#### Town of Surfside DESIGN REVIEW BOARD/ PLANNING & ZONING BOARD AGENDA

June 27, 2018 – 6:00 p.m.

# A. 8995 Collins Avenue – Site Plan; Conditional Use for Hotel Pool and Alternative Parking System; Variances for Landscaping and Loading Space Size

## **SITE PLAN REPORT**

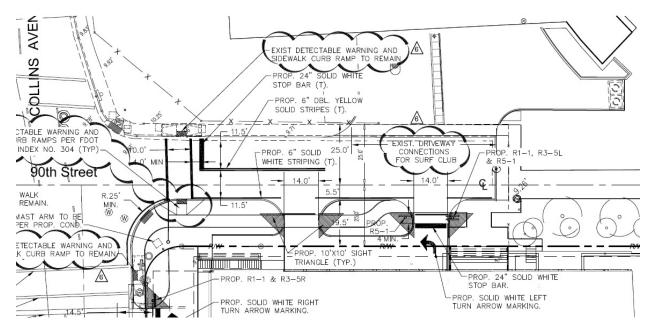
1. Projects that have direct or immediate access or is within one-half block of Collins Avenue, Harding Avenue or 96th Street shall be subject to the review and approval by FDOT for compliance with FDOT standards. Please provide an approval letter from FDOT as part of your resubmittal. (Town of Surfside Code Section 90-81.11)

Tom Hall 04/23/18 Response: The Permits Section of the Florida Department of Transportation's District VI office does not provide "Pre-App" letters in the manner of District IV. Therefore, it is not possible to provide the requested letter until the time that a Driveway Permit is applied for. As soon as the Driveway Permit is obtained, a copy will be provided to the Town.

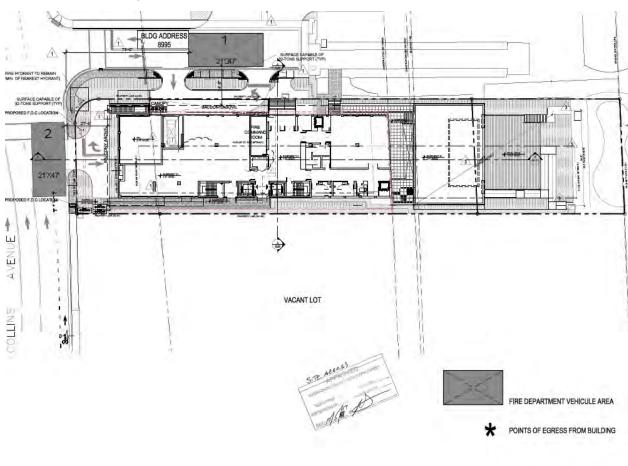
7. Please either label the directional arrows that are shown on the pavement marking and signage plan as "informational only" or remove the symbols from the plans. It is unclear from the design plans if these are to be installed as part of the project.

Ocean Engineering, Inc. 04/23/18 Response: the directional arrows have been removed from the pavement marking and signage plan. (WL)

Figure 2 – P.M. Peak Hour Traffic Counts 8995 Collins Avenue Town of Surfside, Florida

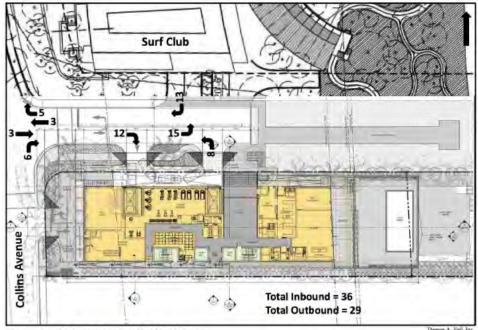
As the reviewer can see by perusing the enclosed four-run-average Simtraffic queue report, the maximum queue, which is the total queue, not a percentage of the queue, is 49 feet in length. Simtraffic considers one vehicle length to be 19.5 feet in its queuing analysis so the average maximum queue observed in the four runs, 49 feet, is equivalent to 2.51 vehicles, or for practical purposes, three vehicles.

CGA response: Addressed. The applicant provided a new 8995 Collins Valet Parking Operational Plan which depicts the staged valet operation. It should be noted that there is limited space for eastbound left turning vehicles into the Surf Club development to queue on 90<sup>th</sup> Street. The Simtraffic queue report identifies an EBL queue of 54 LF (around 3 vehicles). The post development valet operational analysis study will need to evaluate not only the valet operations at 8995 Collins but also the traffic operations within 90<sup>th</sup> Street including the driveway operations at the Surf Club and 90<sup>th</sup> Street.
